HISTORIC PRESERVATION COMMISSION

STAFF REPORT Department of Growth Management

MEETING DATE:	February 3, 2016
PROJECT:	Lot 2A, 5739 Guilford Place – New Construction: Single-Family Residential
APPLICANT:	Pearce Scott Architects
PROJECT MANAGER:	Katie Peterson, Planning Assistant

PLAN REVIEW COMMENTS FOR COFA-10-15-009383

**SITE PLAN &
SECTION**
SHEET NO.

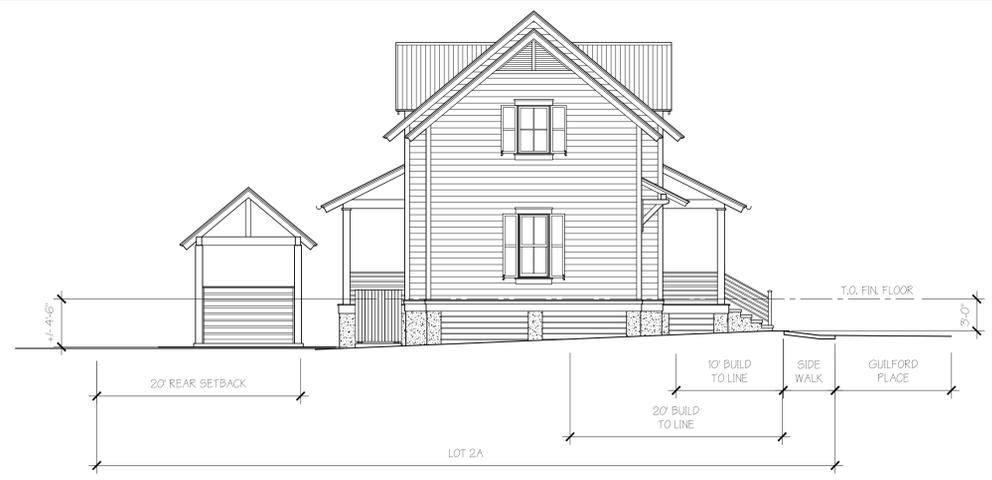
- 1) Section 5.7.4.A.5. - Lot Layout and Design. As shown on the site plan access to the lot is currently proposed from Lot 3A. The UDO states that every lot shall have access to a public or private roadway and that the access may be recorded via a cross or shared access easement. Provide a shared access easement.

**EXTERIOR
ELEVATIONS**
SHEET NO.

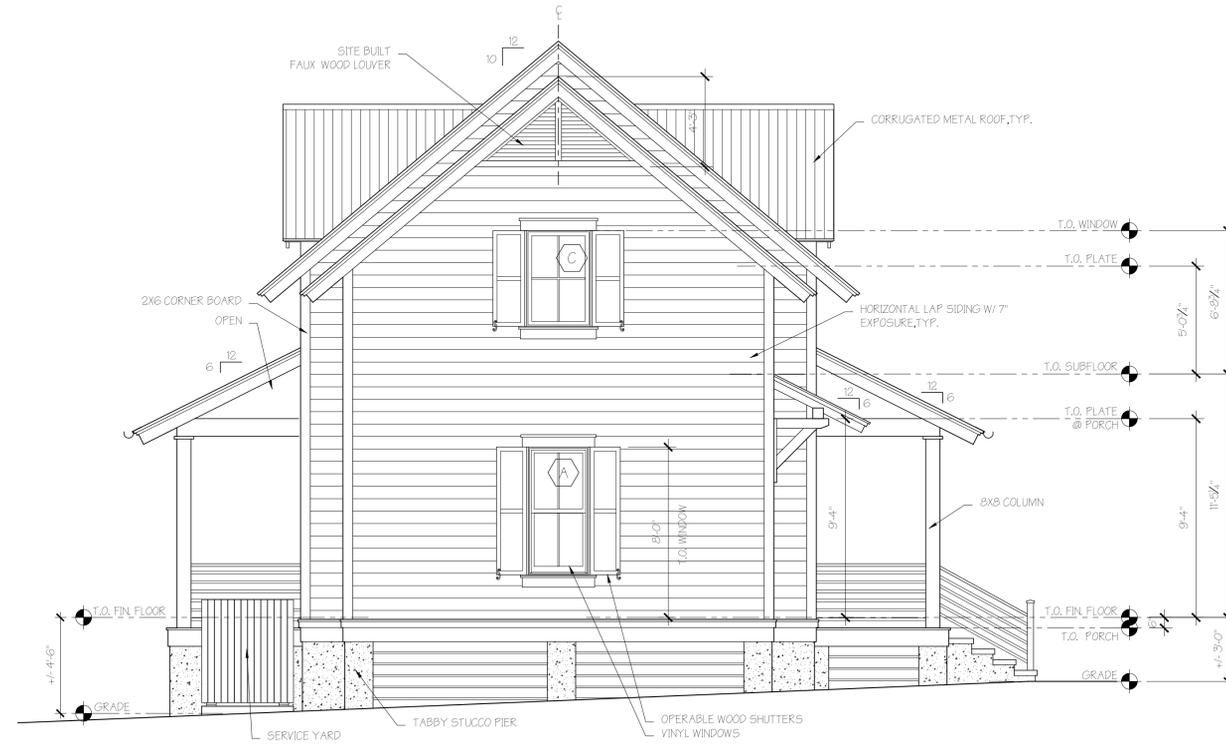
- 2) Section 5.15.6.H.1.A. – Columns, Arches, Piers, Railings, Balustrades. The UDO states that column spacing must be “no farther apart than they are tall”. The columns at the rear porch are approximately 9’ tall and spaced approximately 12’ apart. To meet the requirements of this section the column spacing must be modified or additional columns added to meet the requirement.

Recommendation: The center support for the railing on the rear porch is set behind the railing. A more traditional composition would be to have the railings terminate in the support rather than be set in front.

Recommendation: The use of shutters is inconsistent throughout the elevations. It is recommended that the use of shutters be revised to be more consistent.

7. It is recommended that the rear porch railing be revised to be a more traditional configuration.

2 1/4" = 1'-0"
RIGHT SIDE ELEVATION

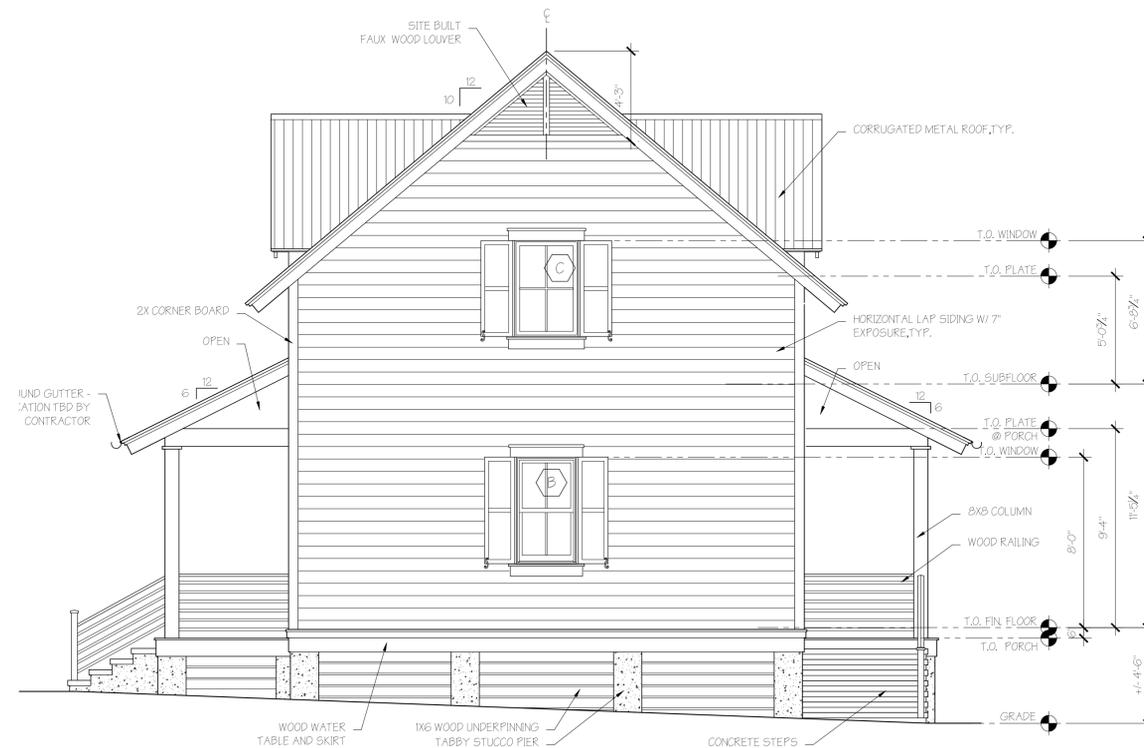
HPRC Review	01/11/2016	Erin Schumacher	Approved with Conditions	
Comments: 1. On the left and right side elevations, the rear porch with steps down to grade and HVAC compressor enclosure do not match what is depicted on the floor plan. Update plans to coordinate floor plans and elevations. 2. The window at the stairs on the rear elevation, above the HVAC compressor, looks as though stair framing will pass behind the window. Consider redesigning the stair as this is not an ideal configuration. 3. Reconsider the design of the second flood dormer.				
Stormwater Review	01/11/2016	William Baugher	Approved with Conditions
